### MetroLink Preferred Route Public Consultation

Dublin Cycling Campaign is a registered charity that advocates for better cycling conditions in Dublin. Dublin Cycling Campaign is the leading member of Cyclist.ie (Irish Cycling Advocacy Network). Our mission is to build a liveable city where people of all ages and abilities can cycle.

Figure 12, Appendix M. Tara Street Station - MetroLink Report

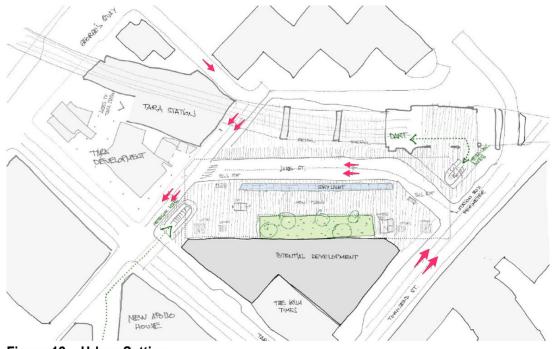
The MetroLink team need to consider the design of the new road network around the Tara Street station. The drawings show Luke Street, New Luke Street, Poolbeg Street, Townsend Street and Tara Street all as one-way streets. This will make access to the station difficult for people on bikes.

The MetroLink team could make access to these stations by bike easier by adding contraflow cycle lanes to these one-way streets. This would increase permeability of the area for people on bikes. It would also connect the Tara Street station to the Liffey Cycle Route. It would also align with objective MTO13 of the Dublin City Development Plan to provide contraflow cycling on one-way streets.

Extract from the preferred route public consultation document

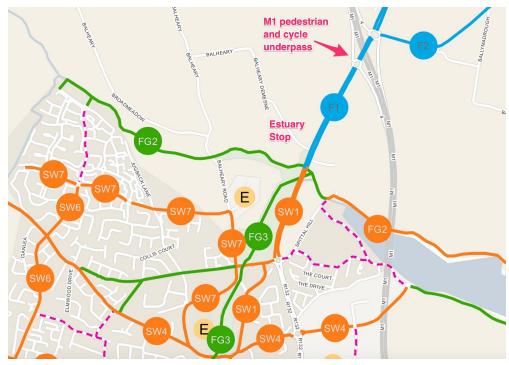
TII need to clarify the proposals around Lissenhall/Estuary. This was an issue we raised in our submission to the EPR. It appears that the MetroLink tracks will cut through existing or planned walking and cycle routes in the area.

It is not possible to access the the Estuary metro station from Swords by foot or bike. The segregated metro track prevents access. The track also will block the completion some of routes of the NTA's GDA Cycle Network Plan.

How can a pedestrian or cyclist travel from point A to point B on the map above? It does not look possible to cross the MetroLink tracks or the River Broad Meadow. Connection between points B and C by foot or bike is now possible by utilising the historic Lissenhall Bridge.

If it is impossible for pedestrians and cyclists to cross the MetroLink tracks south of the Broad Meadow River then MetroLink will cause community severance. There are potential solutions. The metro bridge over the Broad Meadow River could provide enough space for pedestrians and cyclists to cross underneath.

Figure 16, Appendix K - MetroLink Report

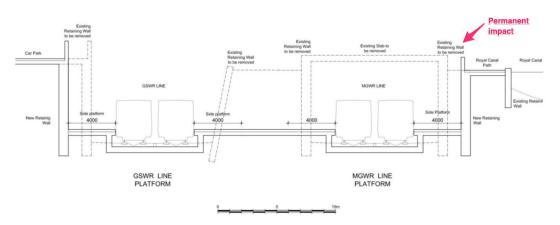
Figure 16, Appendix K of the MetroLink report indicates a permanent impact on the Royal Canal Greenway in order to provide a 4m heavy rail platform. This would be unacceptable. A solution must be found.

If TII must close the Royal Canal Greenway during construction then TII must provide a suitable alternative on the south bank of the canal. This will allow pedestrians and cyclists to bypass the construction area. This will require a bridge over the Royal Canal for pedestrians and cyclists.
